MONTCLAIR STATE UNIVERSITY

ADDENDUM NO. 2

Request for Proposal # 779

<p>architects interior designers engineers</p> <p>250 Westmoreland Blvd. 201 Montclair, NJ 07042 908.241.8800 cubellis@coplan.com www.cubellis.com</p>	<p>TITLE REFLECTIVE CEILING PLAN</p>	<p>PROJECT MALLORY HALL UPGRADES PHASE II MONTCLAIR STATE UNIVERSITY MONTCLAIR, NJ</p>	<p>PROJECT NORTH</p>	<p>NO</p>	<p>DATE</p>	<p>REVISIONS</p>
	<p>DATE 5.14.2008</p>	<p>CHECKED BY MP</p>		<p>SCALE AS NOTED</p>	<p>5.06.08</p>	<p>ADDENDUM #1</p>
<p>DRAWN BY VF</p>	<p>NO</p>	<p>DATE</p>	<p>REVISIONS</p>	<p>5.14.08</p>	<p>ADDENDUM #2</p>

SK-2

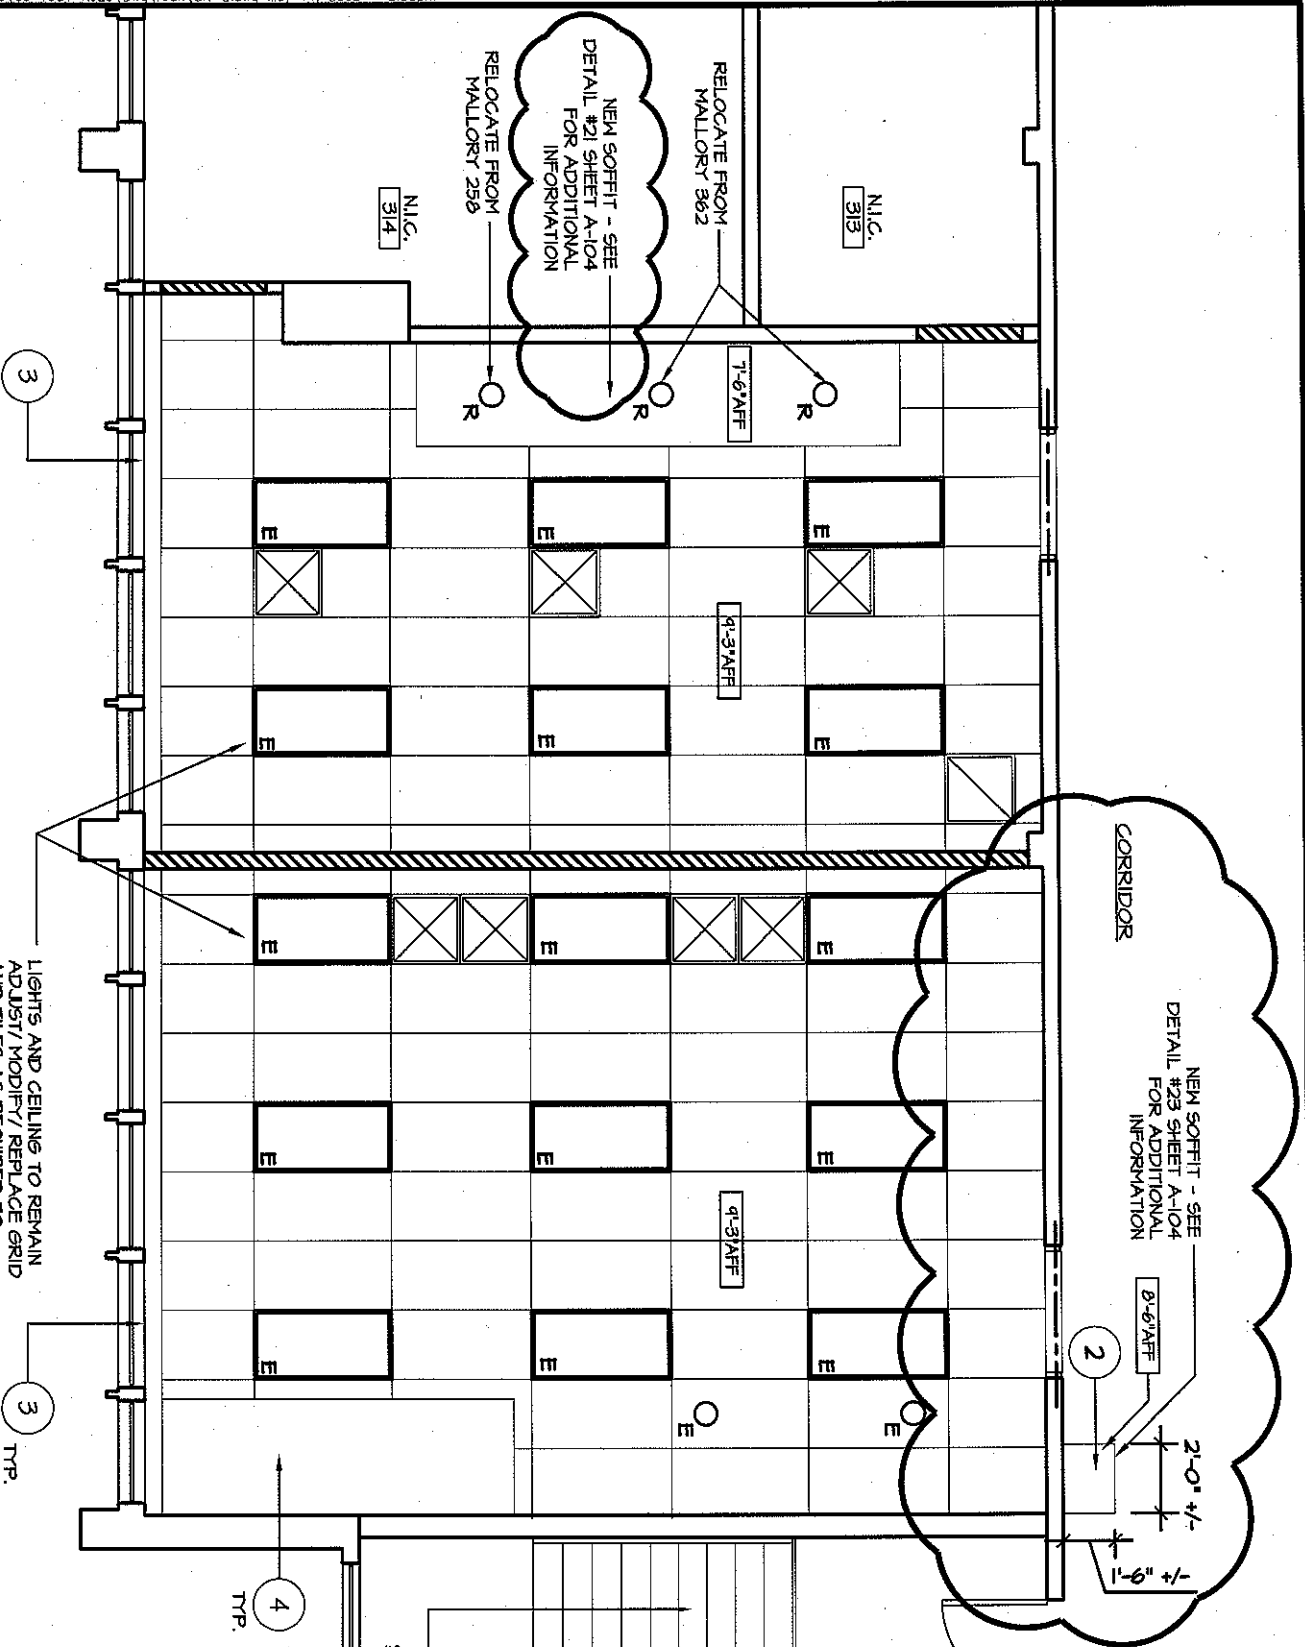
13. Question: On Drawing PM 103 Note 44 please provide detail for (1) hour fire rated chase.

Answer: Fire rated chase detail is shown on Drawing A104, Detail 23 "2-HR F.R. Horizontal Shaft Assembly". See sketch SK-2- Revised Reflected Ceiling Plan for the location of the shaft and other soffits.

LIGHTS AND CEILING TO REMAIN ADJUST/MODIFY/REPLACE GRID AND TILES AS REQUIRED TO ACCOMMODATE NEW LAYOUT. PROVIDE PERIMETER EDGE TRIM AT BOTH SIDES OF NEW WALL, NEW SOFFITS, AND HOOD SKIRTS.
